Erratum

Erratum: The Flow Field of Undershot Cross-Flow Water Turbines Based on PIV Measurements and Numerical Analysis

Fig. 1 The test runner

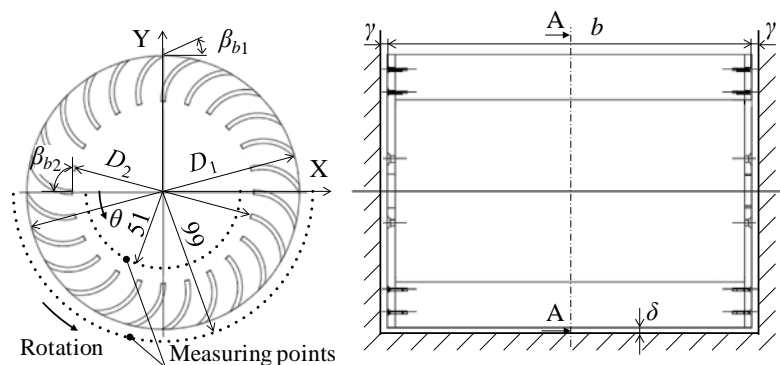
Figure 1 in the original paper is corrected as follows.
